BID BULLETIN No.4

22 August 2025 (Friday)

BIDDING NO.:	TITLE/DESCRIPTION:
IB25-414804-01	“ONE (1) LOT LUMP SUM CONTRACT FOR THE COMPLETION OF UNFINISHED WORKS FOR THE CONSTRUCTION OF THE FOURTEEN-STOREY NEW TRAINING BUILDING, SITE DEVELOPMENT, AND VARIOUS SITE IMPROVEMENTS, INCLUDING SUPPLY AND INSTALLATION OF DESIGN FIT-OUTS, FURNISHINGS, AND FIXTURES AT THE DAP CONFERENCE CENTER IN TAGAYTAY CITY”
APPROVED BUDGET CEILING (ABC):	
PHP1,740,000,000.00	
DATE OF PRE-BID CONFERENCE	
29 July 2025 (Tue); 1:00 PM

This Bid Bulletin No. 04 is issued to clarify items and provisions in the Official Bidding Documents (OBD) for the above-stated project for the information of all concerned, as approved by the BAC and TWG. Accordingly, this shall form an integral part of the OBD.

DAPCC SEWAGE TREATMENT PLANT PROCESS FLOW

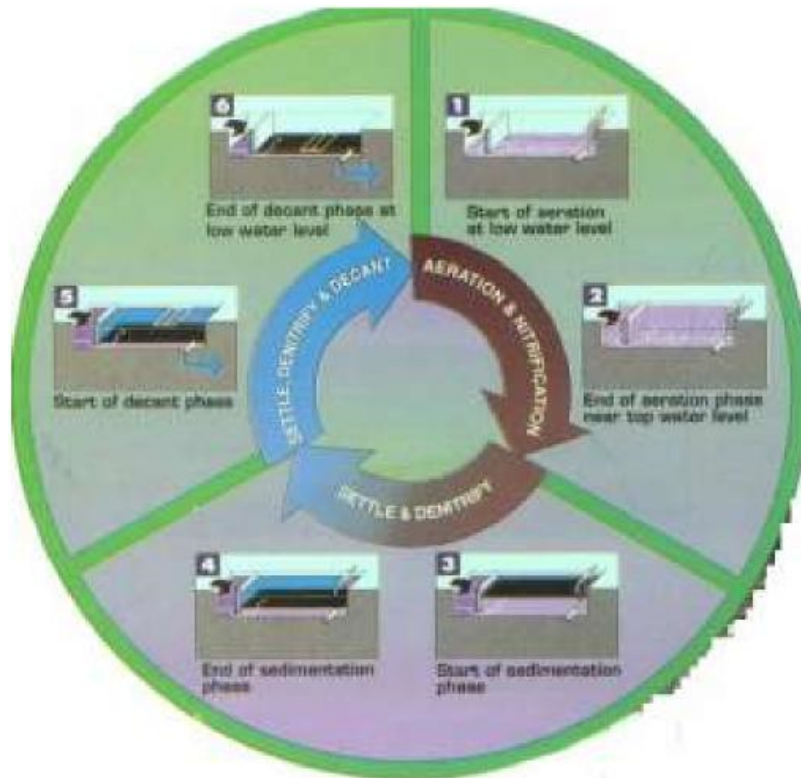
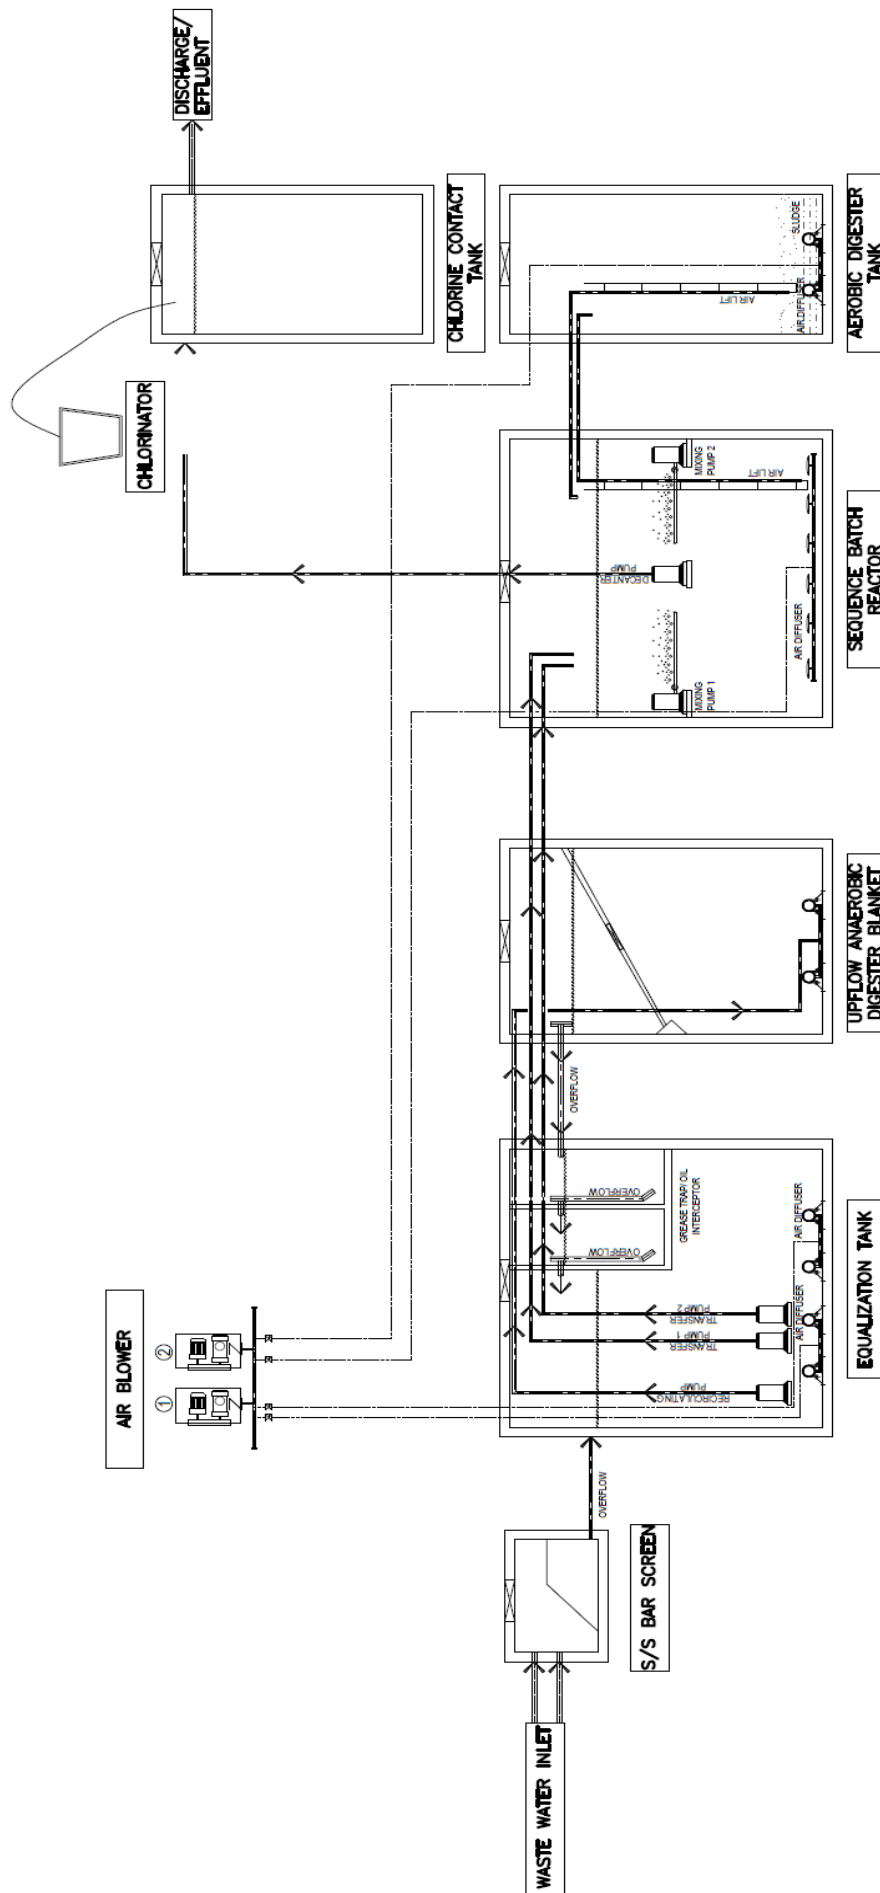
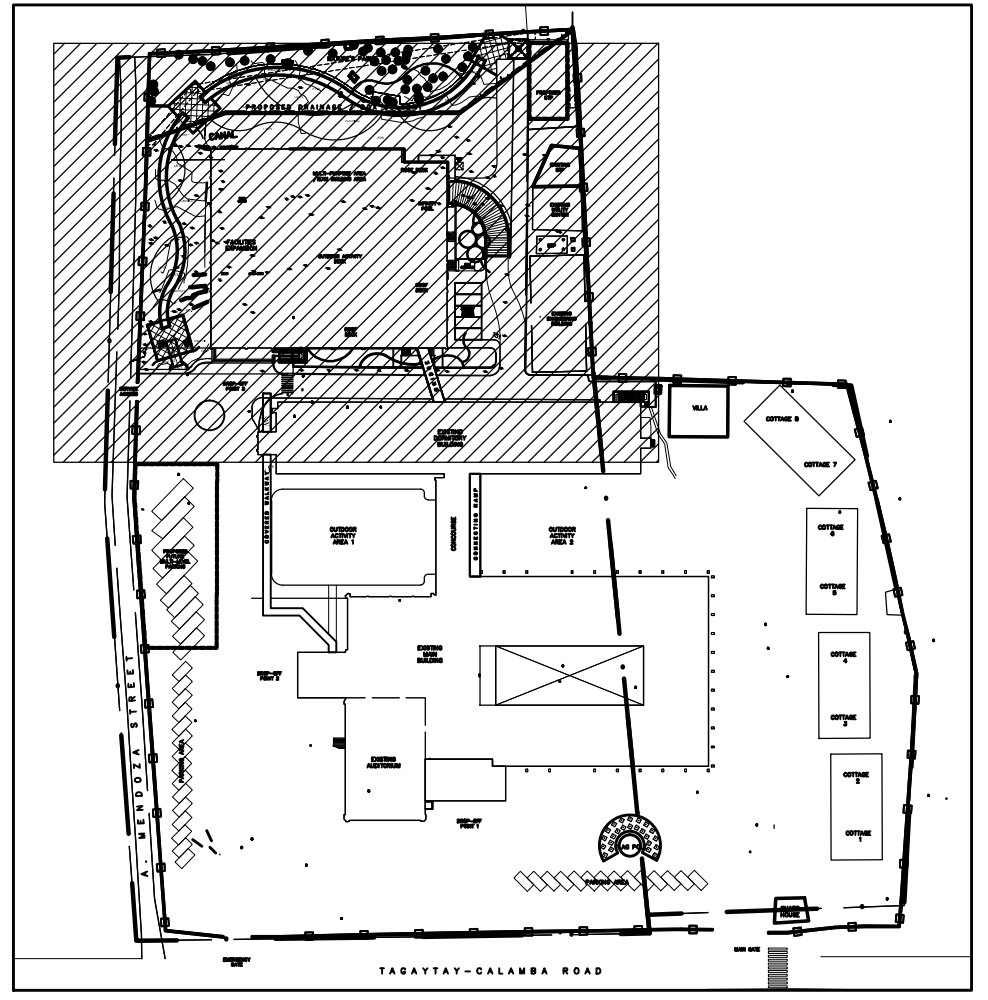
Reference	QUERIES	Responses/Clarifications
Plumbing Plans	6. Provide the Drawing Plan for STP Automation System for Sewage Treatment Plant.	<p>For STP Plumbing Plans, refer to:</p> <ul style="list-style-type: none"> a. P0-2 Site Drainage Distribution Layout with STP; b. P6-1a STP Plans & Sections; c. P6-1b STP Air Diffuser and Waterline Layout; d. P6-1c STP Air Line Layout and Section; and e. P6-1d STP Equipment Layout. <p>For the Design Criteria and STP Process Flow, refer to Annex “A” attached to this Bid Bulletin.</p> <p>The winning Bidder shall nominate three possible suppliers of automation equipment for the New STP, and shall be compatible with the existing STP equipment of DAPCC facility, for approval of the DAP.</p>
Electrical Plans	7. Is there already 400V 3Ø tapping point service within the project site?	Not yet available. This is included in the Bidders' Scope of Work, refer to OBD Section VI, Item No. 2.2.5 for Electrical Works.

4 SECTION-ELEVATION:
TRENCH DRAIN & JOGGING PATH
LGF-SE-03 SCALE 1:20MTS.

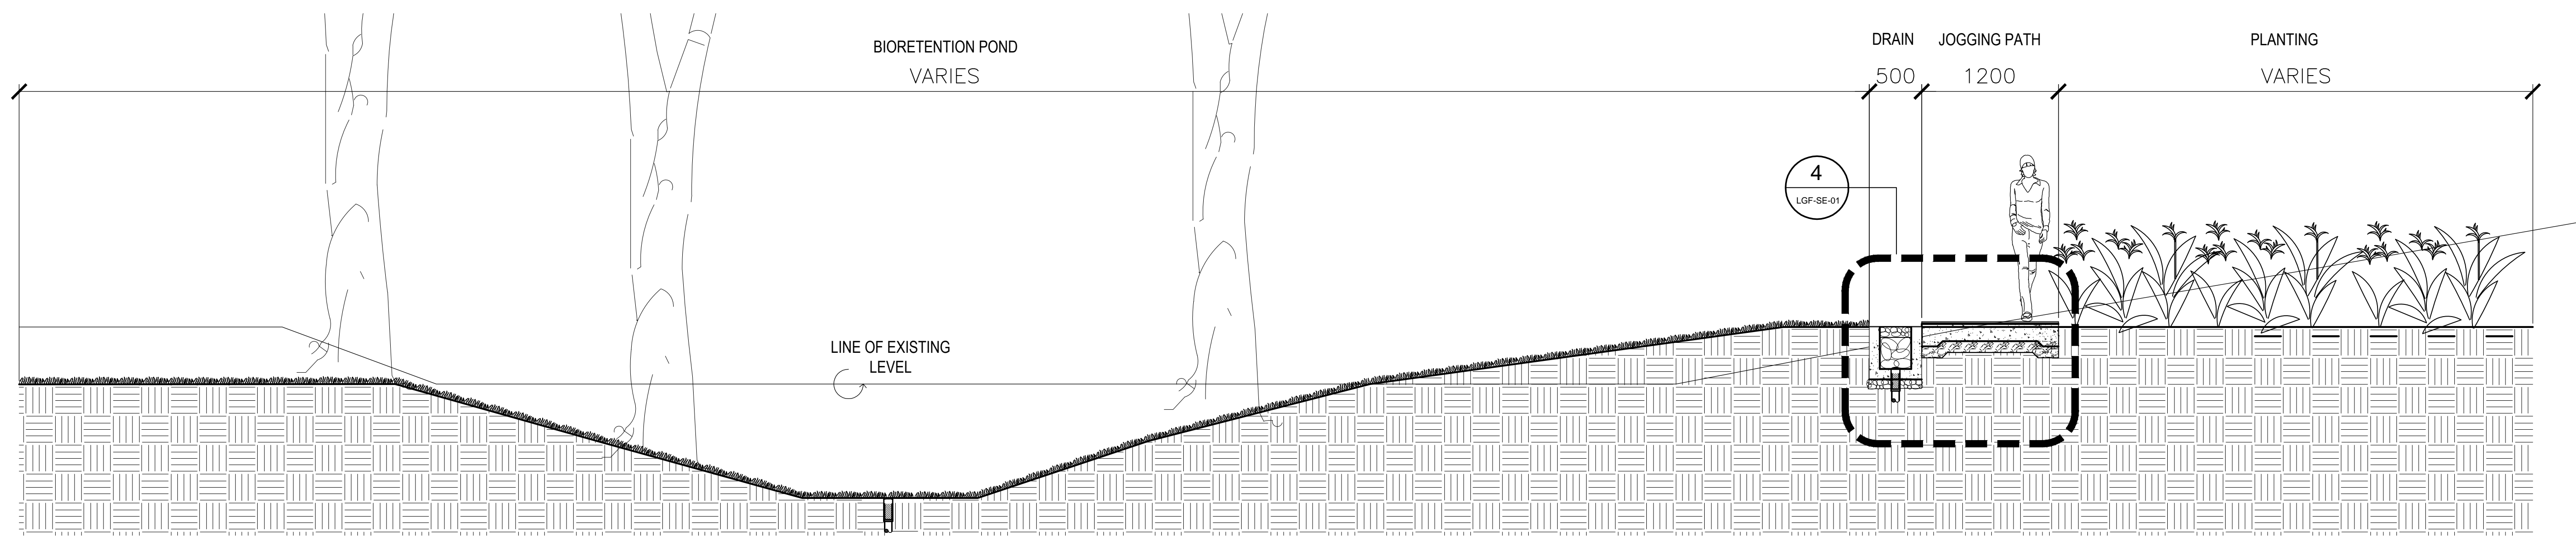
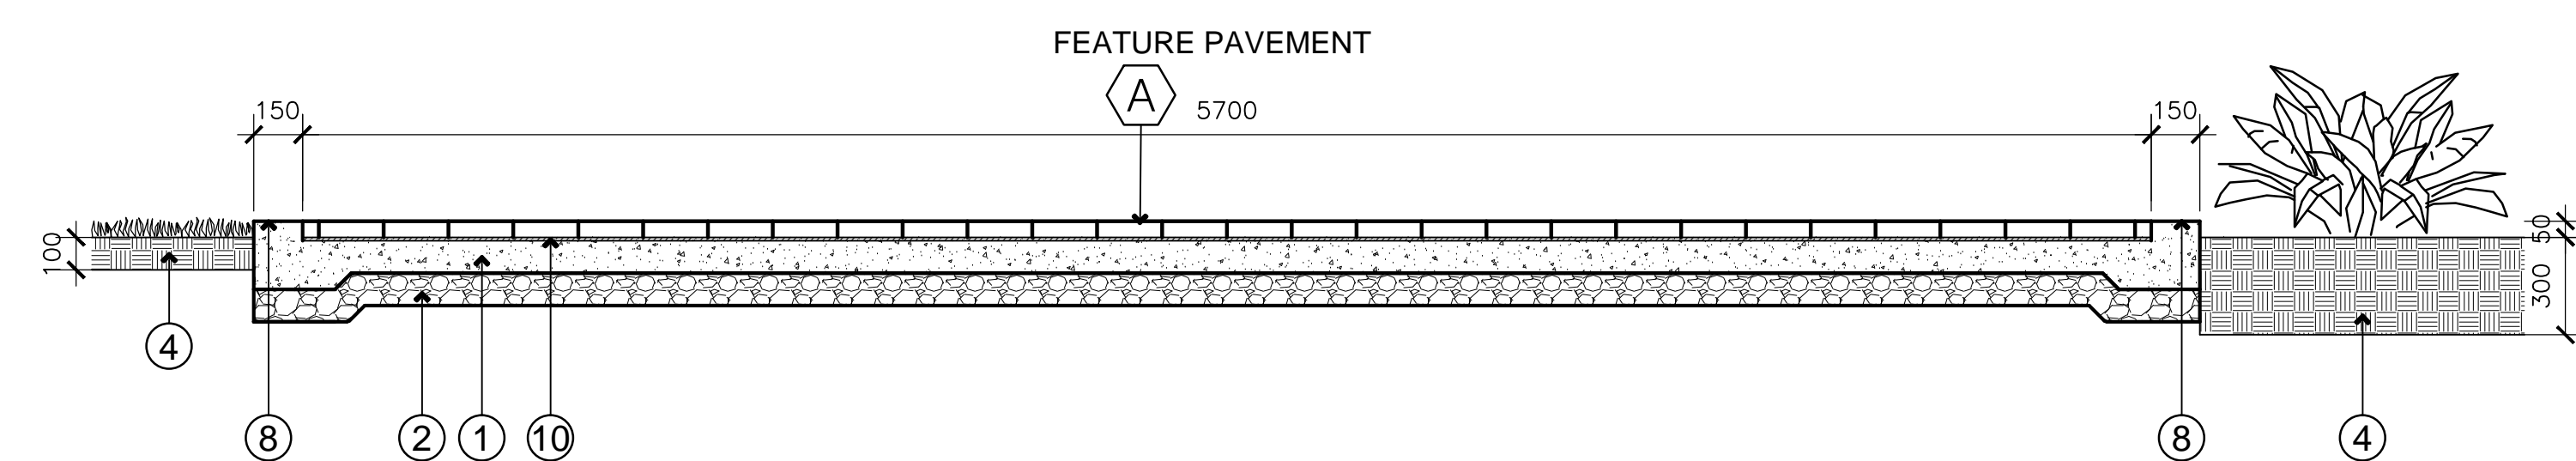
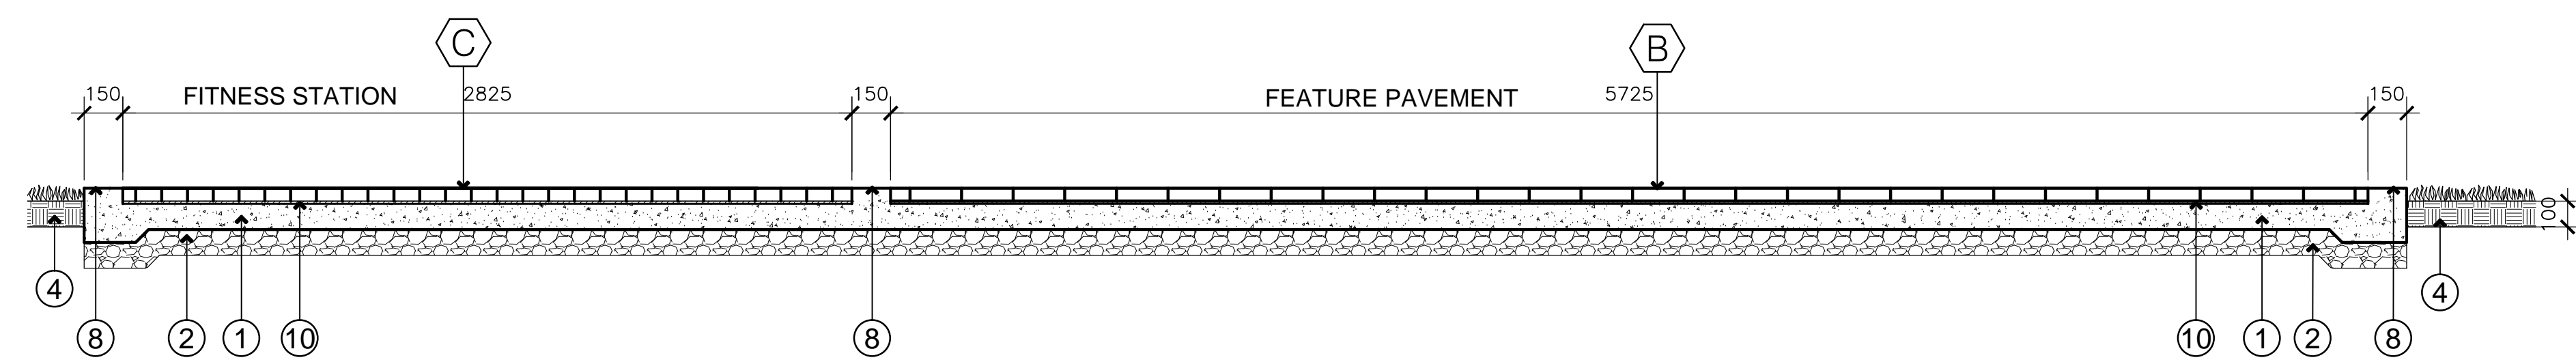
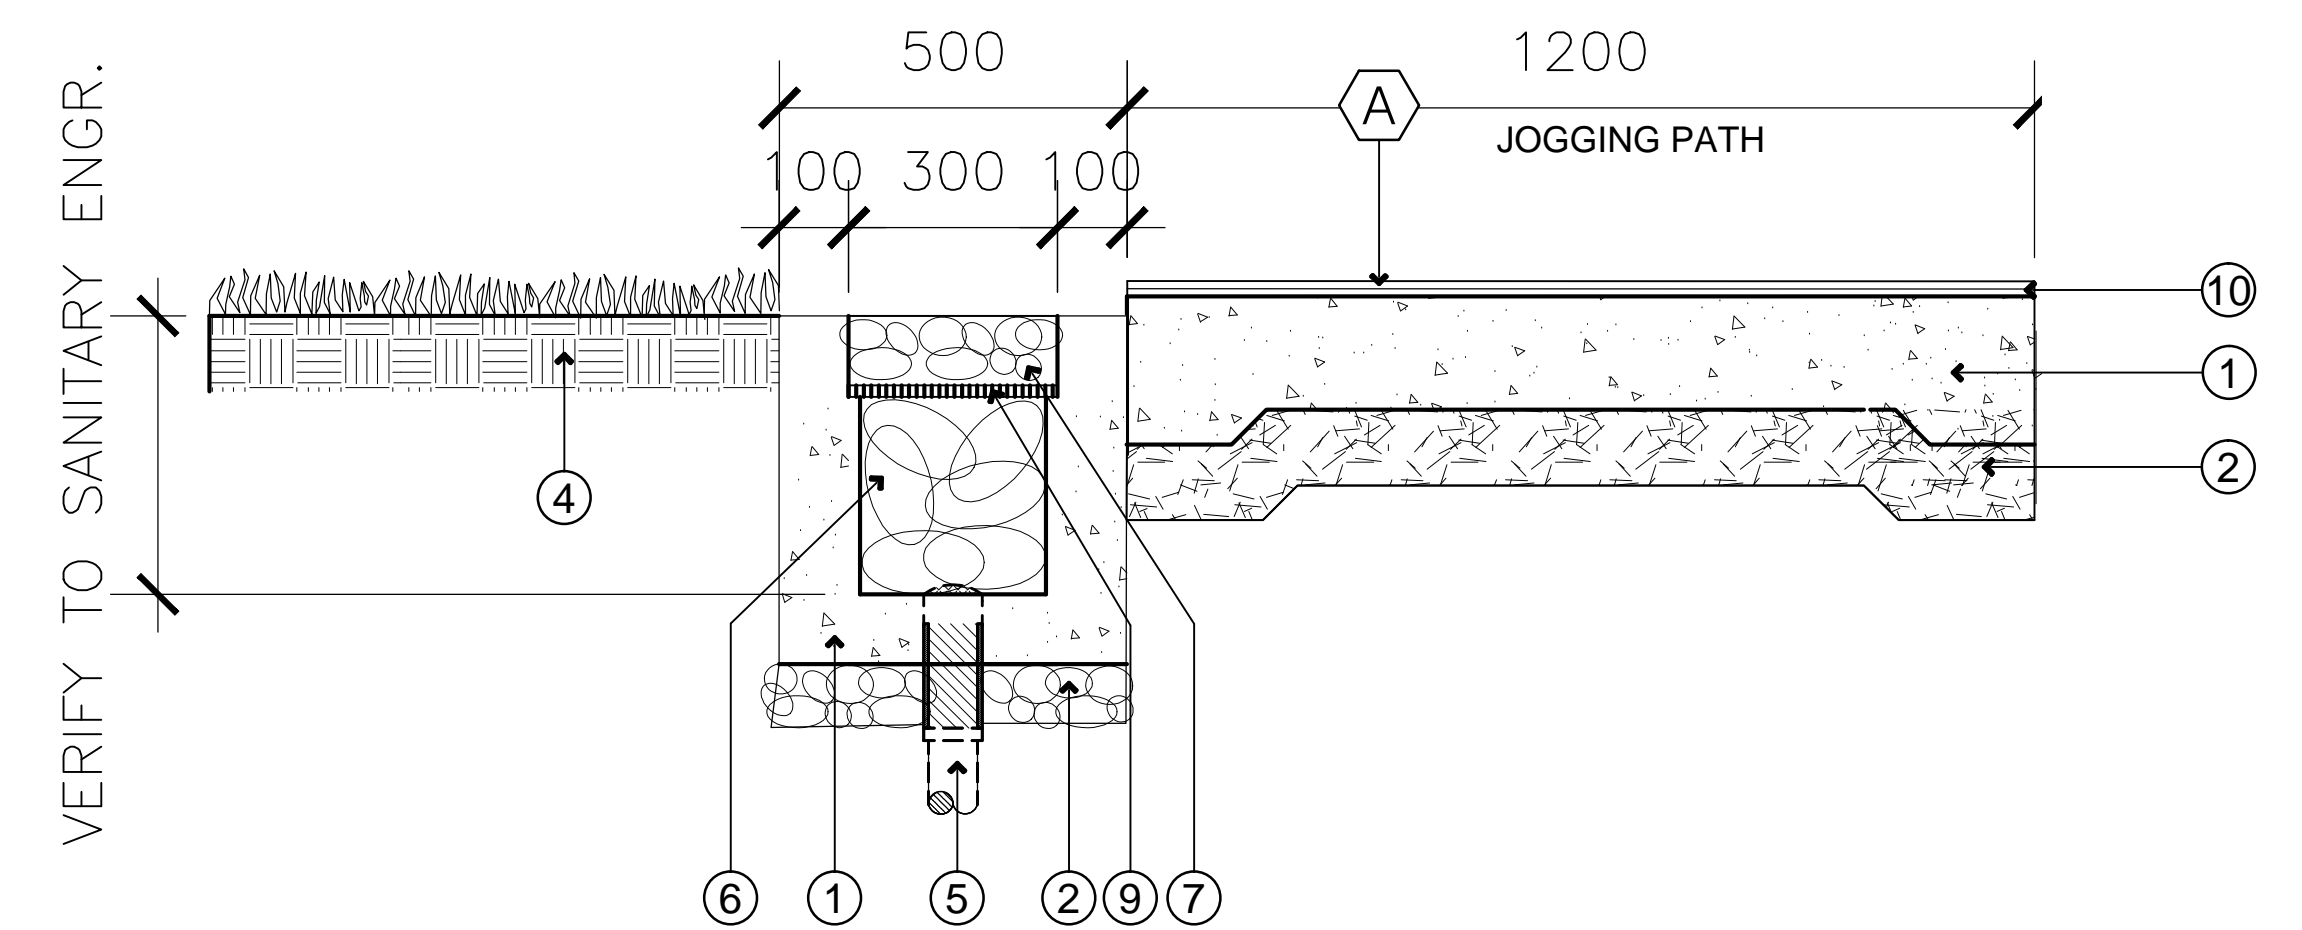
Reference	QUERIES	Responses/Clarifications
	<ul style="list-style-type: none"> Clarification on what is specifically meant by "quick coupler" in this context. 	It is meant for convenient water access, efficient connection and disconnection of irrigation lines.
Landscape Plans	3. For the concreting works of the jogging paths, may we request details on the required thickness and other relevant specifications?	Refer to the Updated Drawing Sheets Nos.: a. 05 LGF-SE-01 Section Elevation; b. 05 LGF-SE-02 Section Elevation; and c. 05 LGF-SE-03 Section Elevation.
Landscape Plans	4. With regard to the Artificial Turf Area, our team would like to confirm whether the artificial turf will already be in place, and if our scope will be limited to the installation of shrubs, garden soil, gravel, and related materials.	Yes, it will be in place. But it will not be limited to the installation of shrubs, garden soil, gravel and related materials. For the complete scope for landscaping works, refer to: a. Construction Plans / Drawings for Landscape; b. Bill of Quantities under Division 32 – Exterior Improvements; and c. Technical Specifications (Part 3) under Division 32, Sections 32 90 00A and 32 90 00B for planting softscapes and hardscapes.
